MITIGATION PLAN

CARPENTER BOTTOM MITIGATION SITE

Re: NCIRT Review and USACE Approval of the NCDMS Carpenter Bottom Mitigation Site /
Buncombe Co./ SAW-2018-02062/ NCDMS Project # 100090

SUBJECT: Carpenter Bottom Mitigation Project - NCIRT Comments during 30-day Mitigation Plan Review

2.1.1

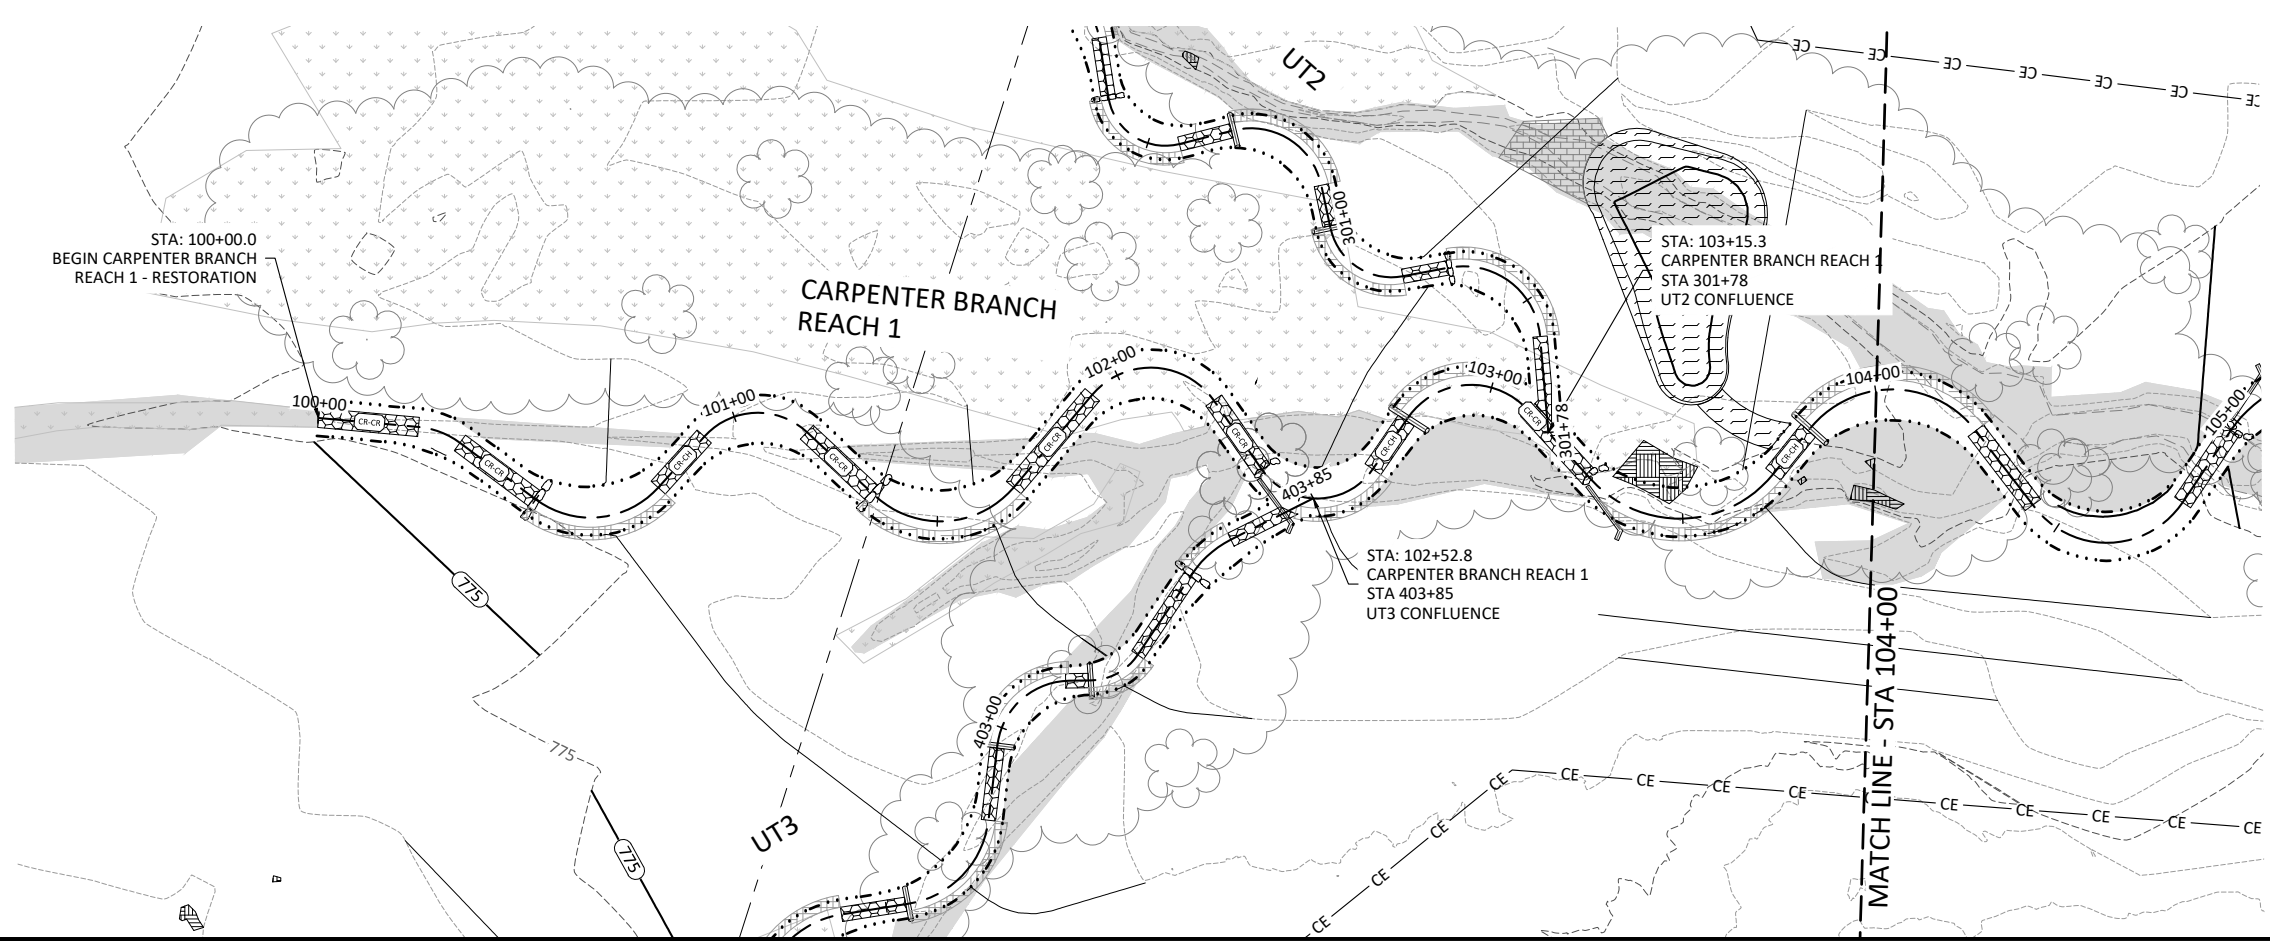
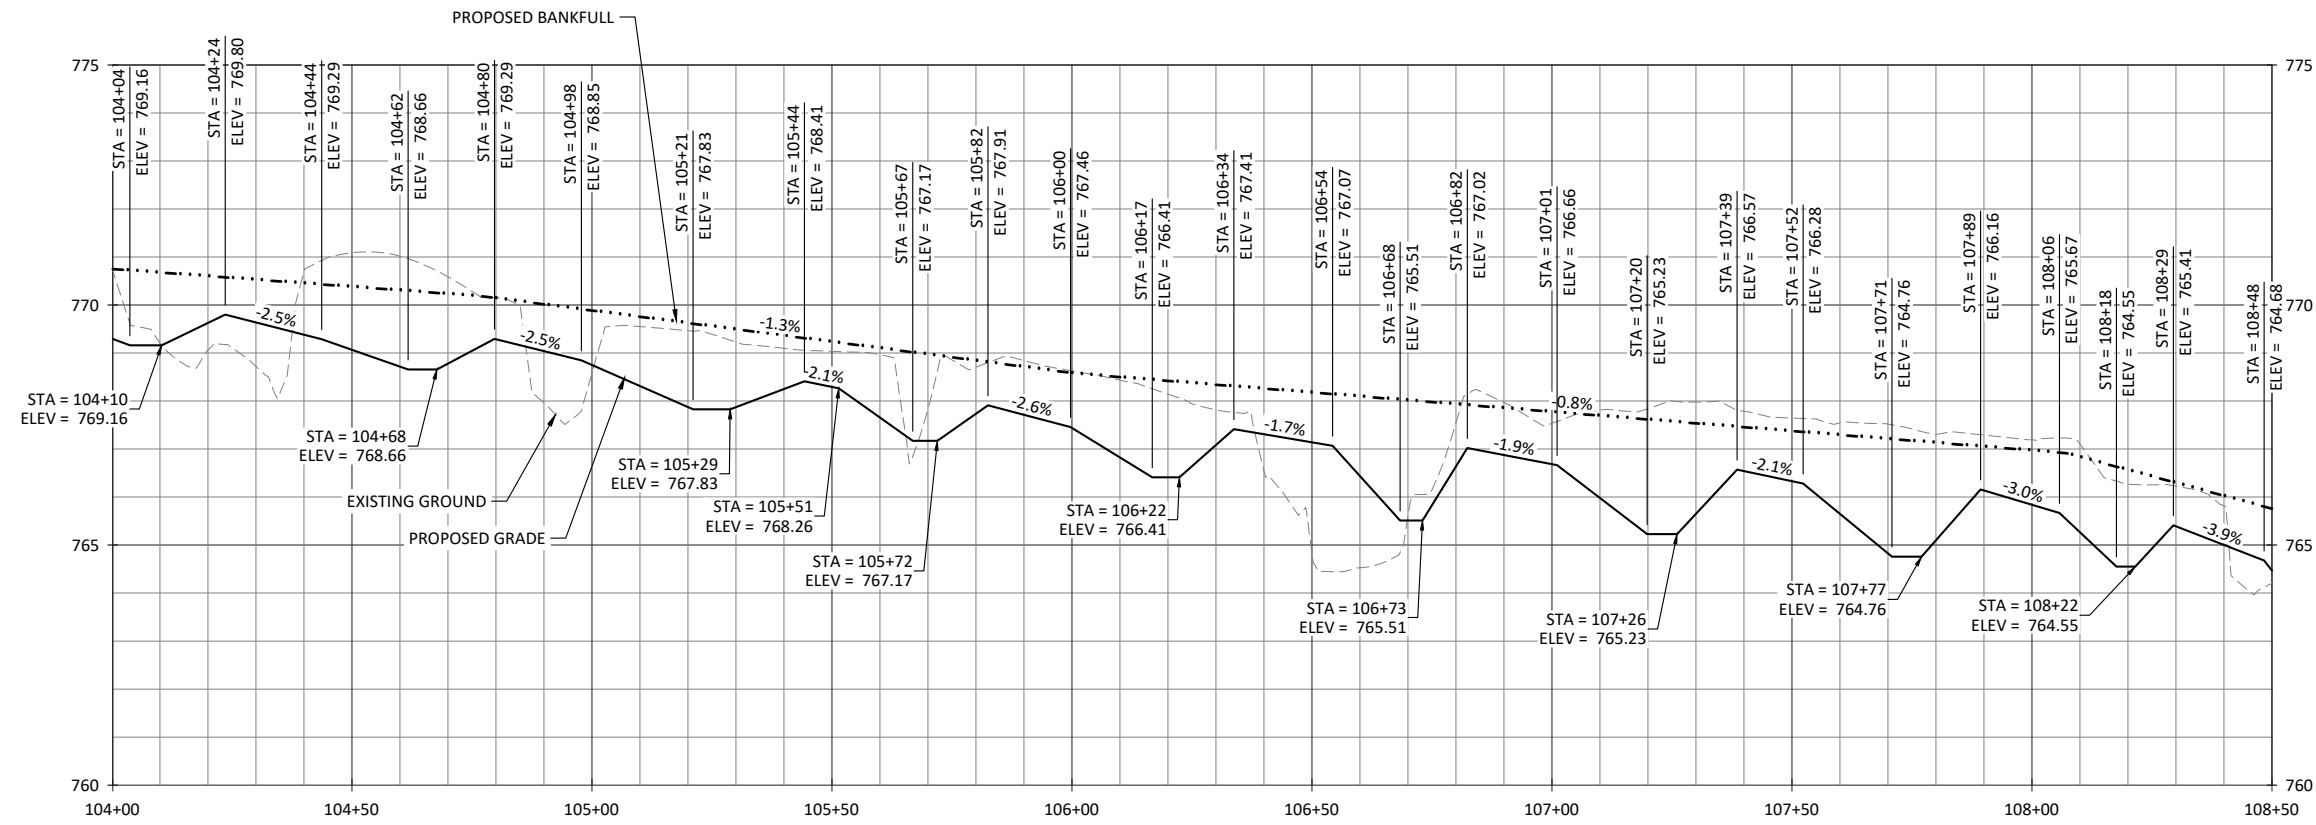
14. *Sheet 2.1.1 – It would help our review to see the existing channel areas proposed to be filled as a shaded feature on the plan view sheets, or for callouts to be added. If ditch/channel plugs area proposed, please identify the approximate locations. Also, please provide detail(s) for ditch/channel filling and plugs.*

Wildlands Response: The Preliminary Design Plans were updated to include a hatch for existing drainage features which will be filled (Sheets 2.1.1 - 3.0). Proposed ditch plugs locations and an associated detail were added to the Preliminary Design Plans (Sheets 3.0 and Sheet 6.1).

Planting Plan

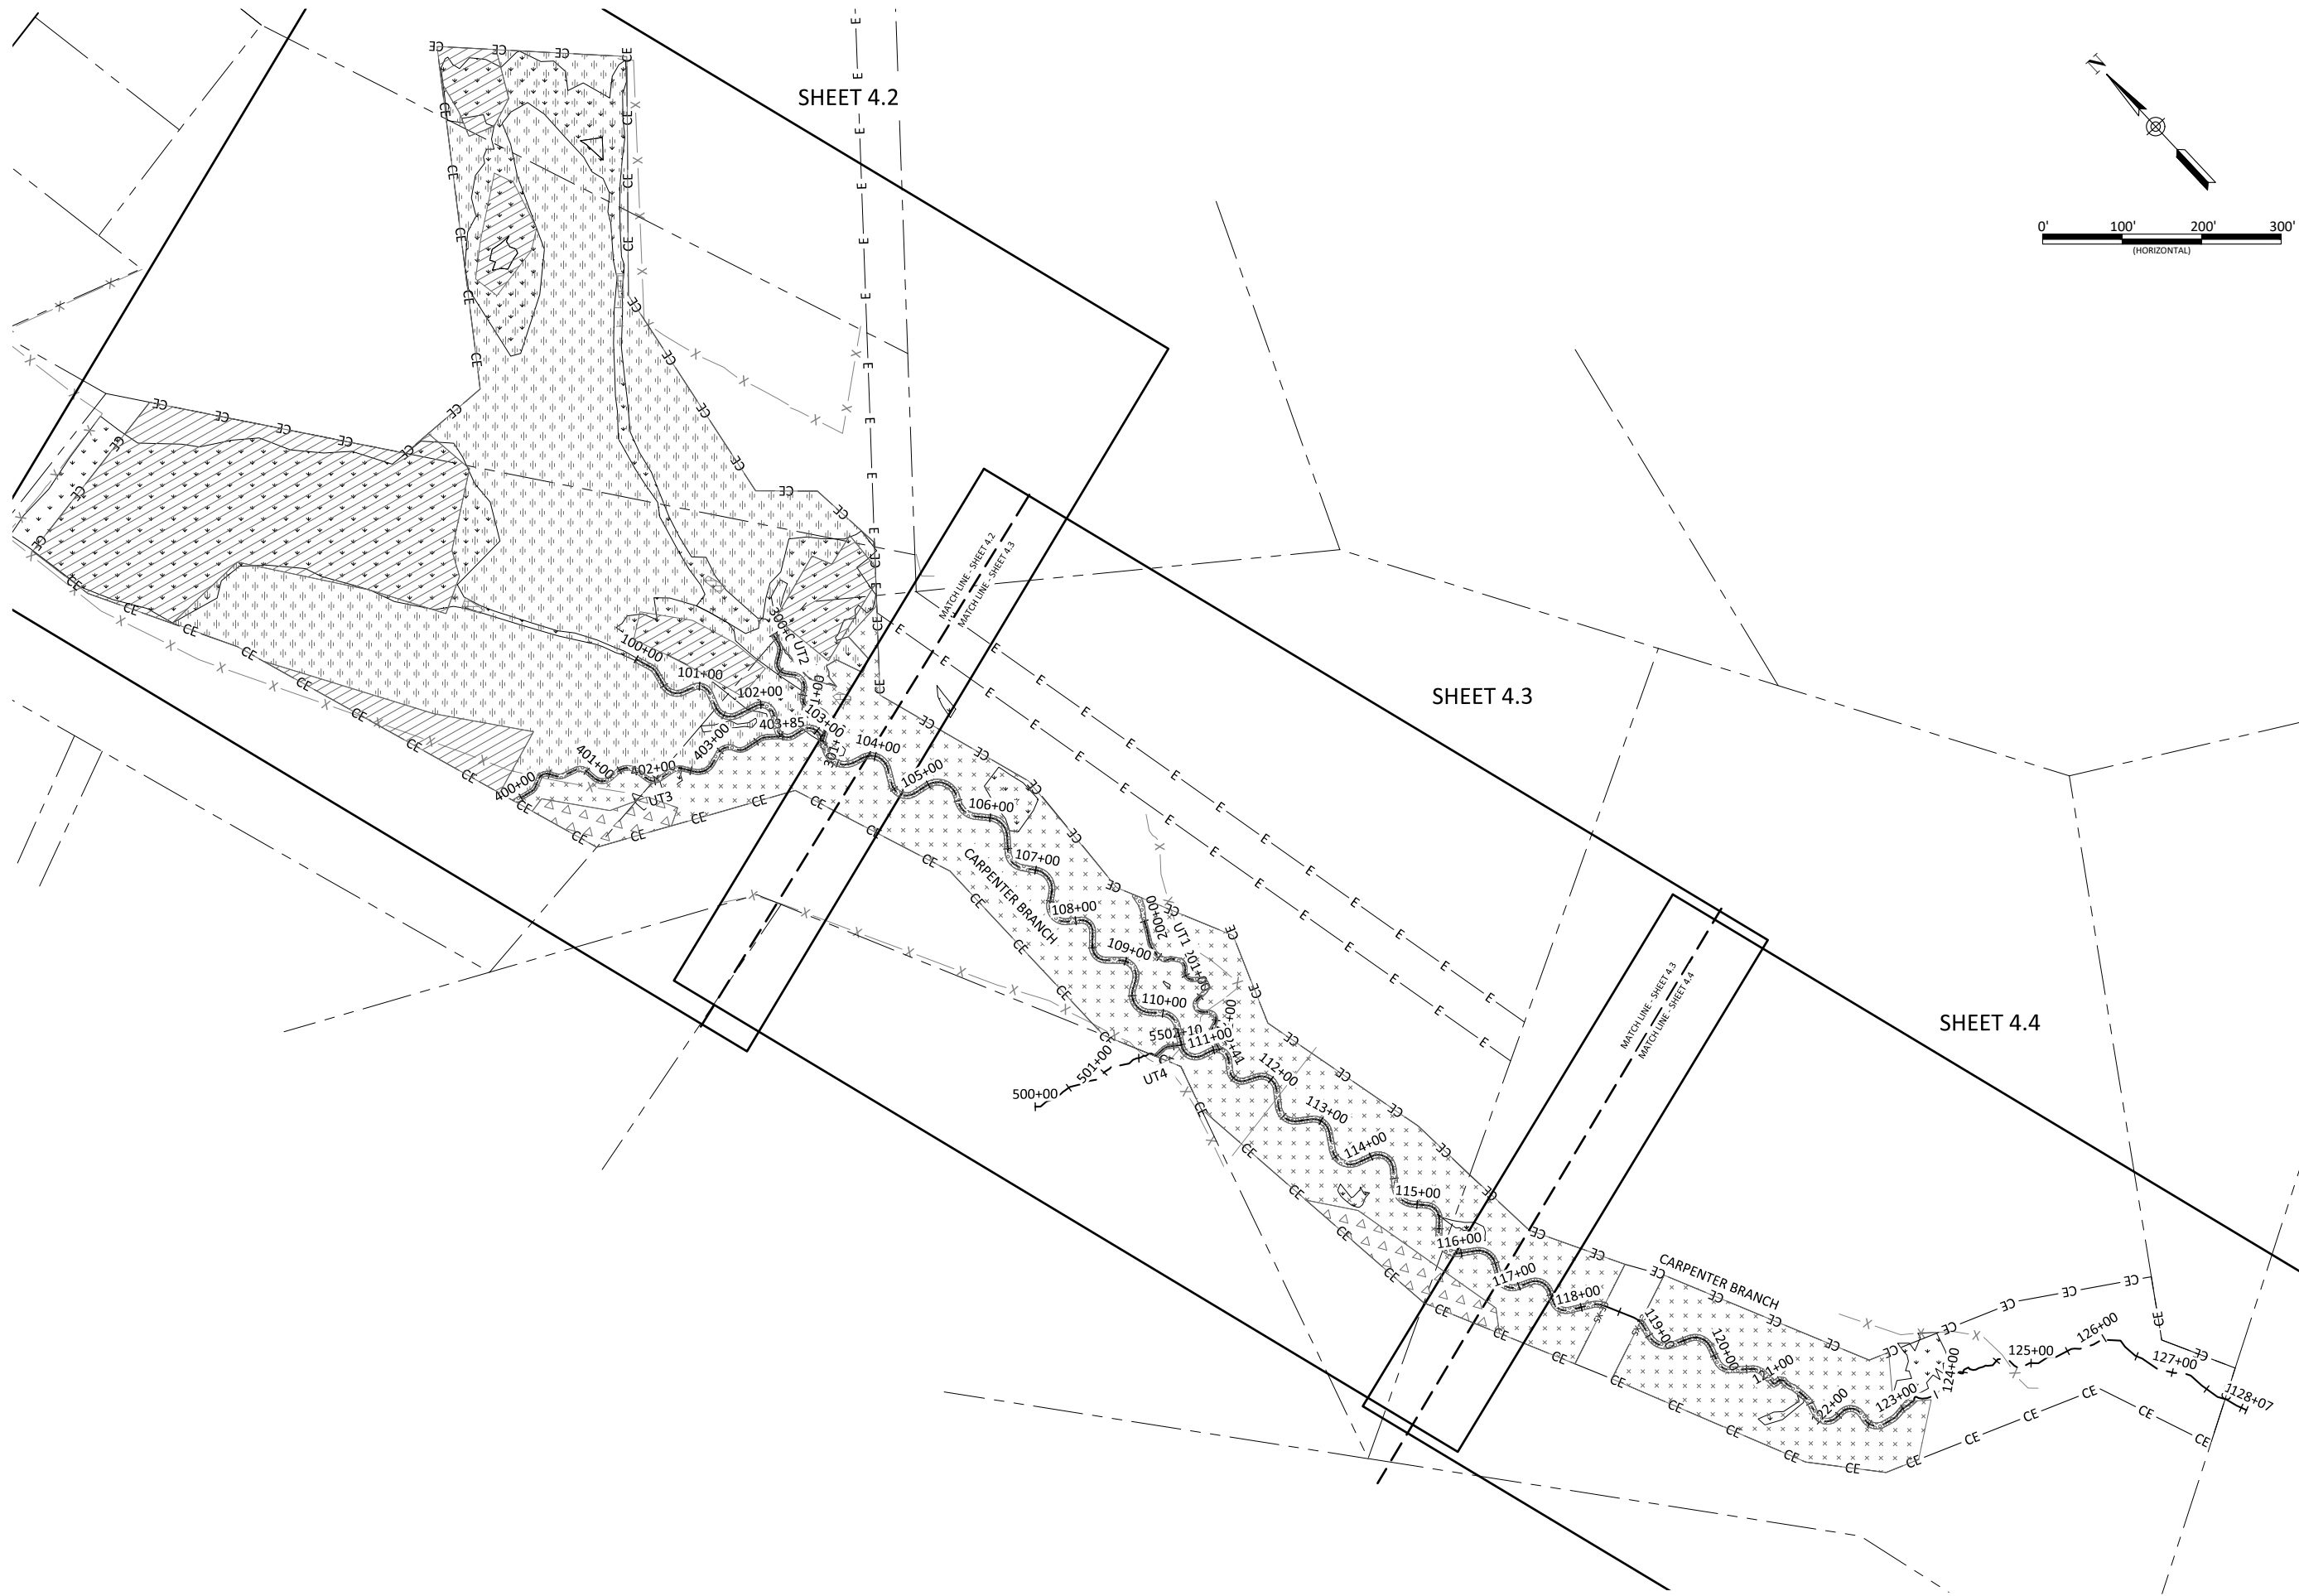
18. Sheet 4.0 –
- a. DWR understands that quantity substitutions may be necessary based on the nursery's species available. However, we request that no species (excluding live stakes) account for more than 20 percentage of a specified planting zone in order to promote diversity within the designated community type.

- b. It would be helpful for our review to have the wetland indicator status included in the tables.
19. Sheet 6.1 – Rock sill – DWR does not support seeding banks with pearl millet or fescue.

18. *Sheet 4.0 –*

Wildlands Response: Alternate species have been added to the proposed planted species list on design sheet 4.0.

Wildlands Response: Wildlands added the wetland indicator status for all proposed plant species in wetland zones on Sheet 4.0.
